PRODUCT / PROCESS CHANGE NOTIFICATION

PCN Number : 0073

General Oscillator Family.

Original
Tray

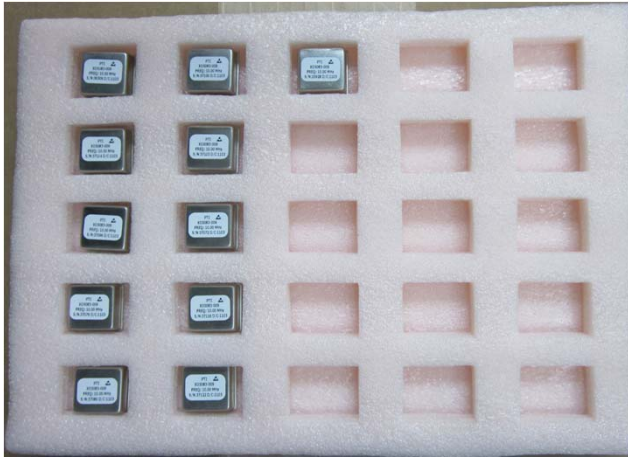
The packaging materials are changing from a "pink-poly" foam tray to a thermoformed ESD plastic tray. Pictures are shown in the secondary tab.

Old Material: Cross linked Polyethylene / Surface resistivity - typical 10¹⁰ ohms / square

New Tray

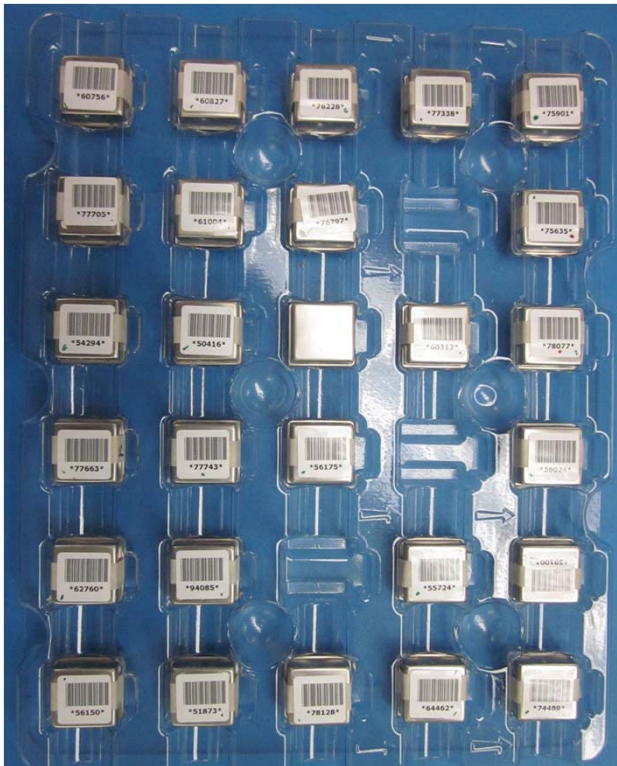
New Material: Permanently Coated Static Dissipative PETG / Surface resistivity - typical 10¹⁰

New thermoformed tray provides increased protection of terminals and feedthroughs in that they are not inserted into the packaging foam, but floating within a cavity. Terminal distortion for through hole and surface mount components has been eliminated with adoption of new packaging material. Clear nature of plastic allows for easier visual inspection of packaged components
